Application Reference: A006978483
Address of Site: 193 BEAMS RD TAIGUM QLD 4018

RE: Further advice

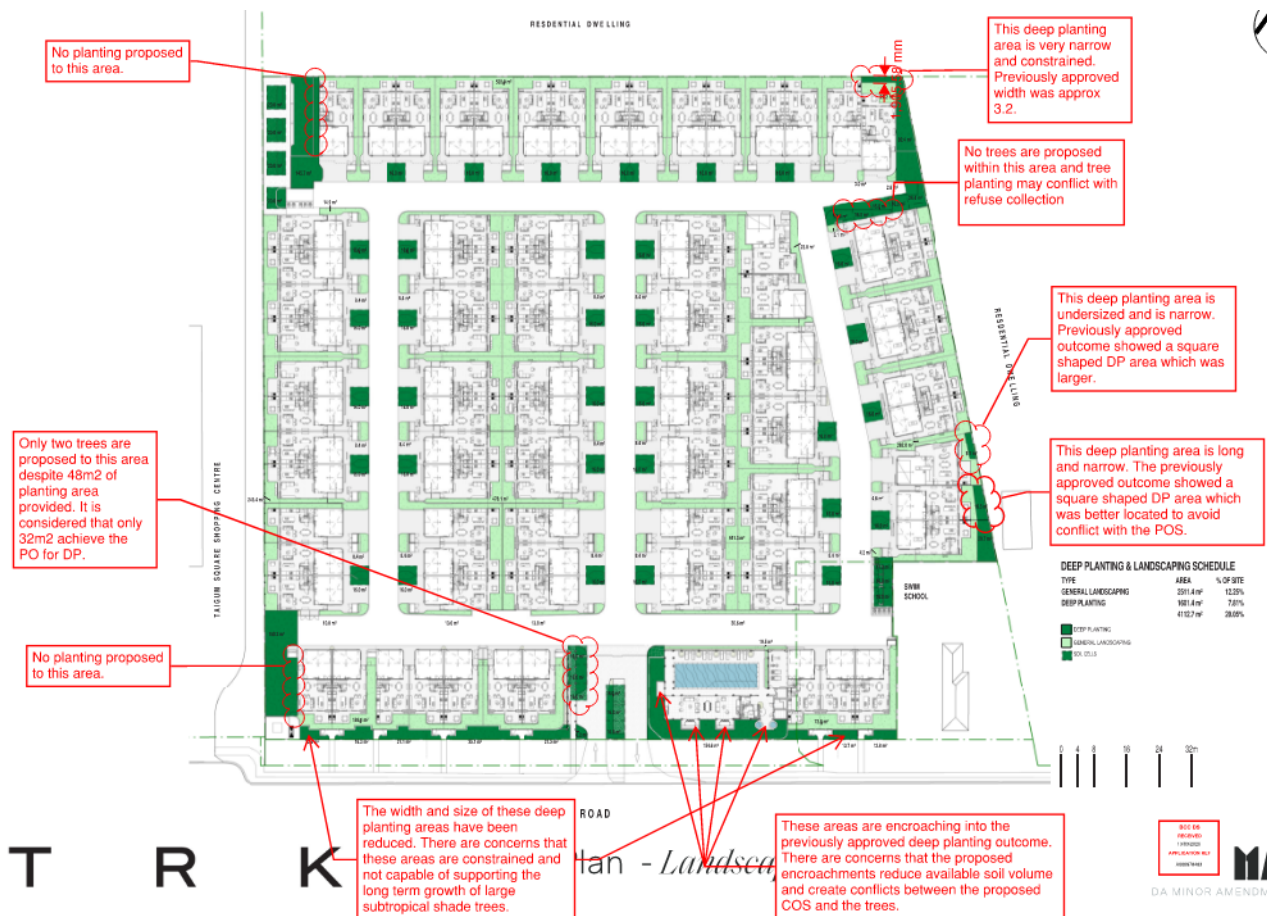
- 1) It is acknowledged that the submitted Assessment report has identified that an overall increase in site area provided as deep planting is proposed. However, after a detailed review of the amendments to the deep planting areas, it appears that many of the previously approved deep planting areas to the site frontage and eastern side boundary have been reduced in size, or the shape has been changed resulting in less functional deep planting areas, or infrastructure such as bin stores are in deep planting areas. It is also noted that the Landscape concept plan does not provide large shade trees in some areas which have been nominated as deep planting and there are now encroachments proposed into the limited areas of previously approved 4m x 4m deep planting. Of particular concern is the proposed encroachment of the communal open space into the deep planting area along the site frontage.

- a) Dimensions of site frontage and eastern side boundary deep planting areas in accordance with the current approval with currently proposed encroachments removed.
- b) Large subtropical shade tree plantings to all identified deep planting areas noting that trees and refuse collection points are to be located to avoid conflict.
- c) Deep planting areas free of conflicting infrastructure and hardstand, such as (not limited to) bin stores and bike parking.

- d) Ensure that the architecture and landscape plans are consistent with each other.
(image below is provided to assist in resolving the above item)

Submit revised drawings (architecture and landscape) in accordance with PO28 and PO29 of the Multiple dwelling code which show:

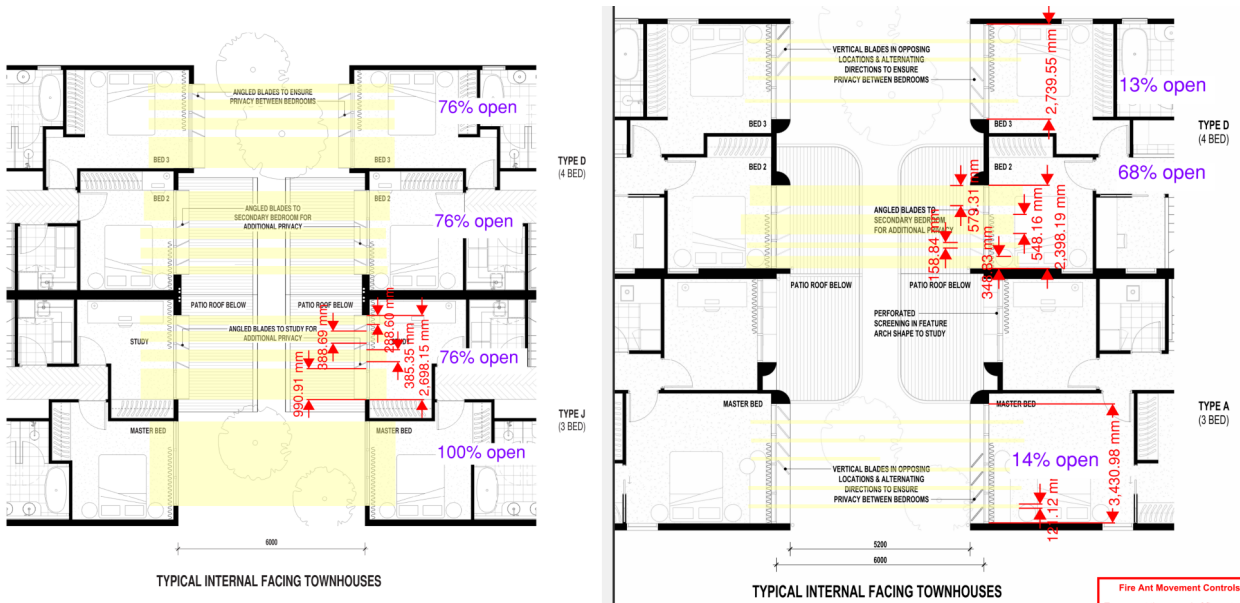
- 2) The proposal to amend architectural conditions 11, 79 and 135 – Final External Detailing of Building, is not currently supported because the submitted plans do not adequately address the accepted or performance outcomes relating to building bulk, form, variation and articulation. The overall site elevations and internal site elevations demonstrate that the built form is simplistic and repetitive, and updated documentation indicates a reduction in variation of materiality with CLD-02 essentially being a minor variation in rendered finish. These changes do not adequately address breaking down building bulk or assist in wayfinding within the development.
- a) Provide updated plans which include additional variation in the built form and external detailing via changes in materials, textures, and colour, addressing the requirements stipulated within conditions 11, 79 and 135.

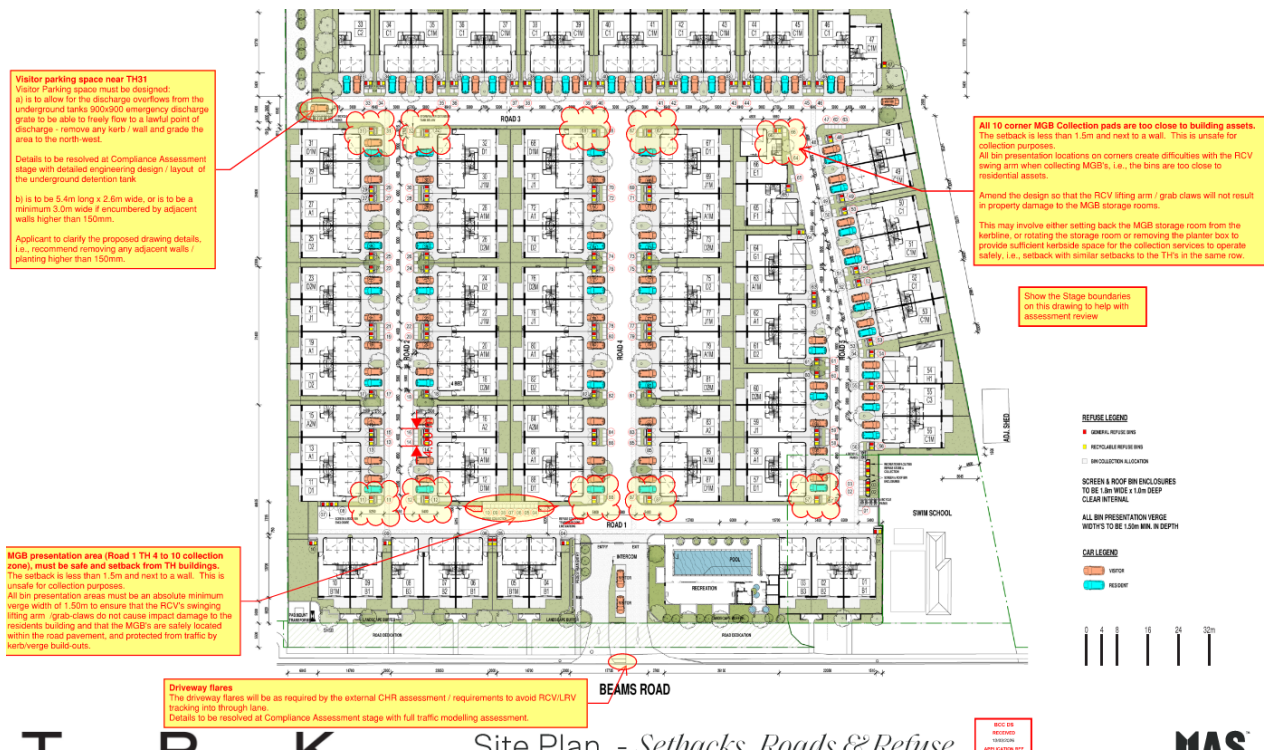
- Amend the Site Plan – Setbacks, Roads and Refuse – to demonstrate bins can be adequately stored and collected. Refer to markups in red attached drawing.
 - All 10 corner MGB Collection pads are too close to building assets to be safely collected. The setback is less than 1.5m and next to a wall. This is unsafe for collection purposes. All bin presentation locations on corners create difficulties with the RCV swing arm when collecting MGB's, i.e., the bins are too close to residential assets.

Amend the design so that the RCV lifting arm / grab claws will not result in property damage to the MGB storage rooms, with minimum verge widths of 1.50m.

This may involve either setting back the MGB storage room from the kerb-line or rotating the storage room or removing/repositioning the planter box to provide sufficient kerbside space for the collection services to operate safely, i.e., setback with similar setbacks to the THs in the same row.
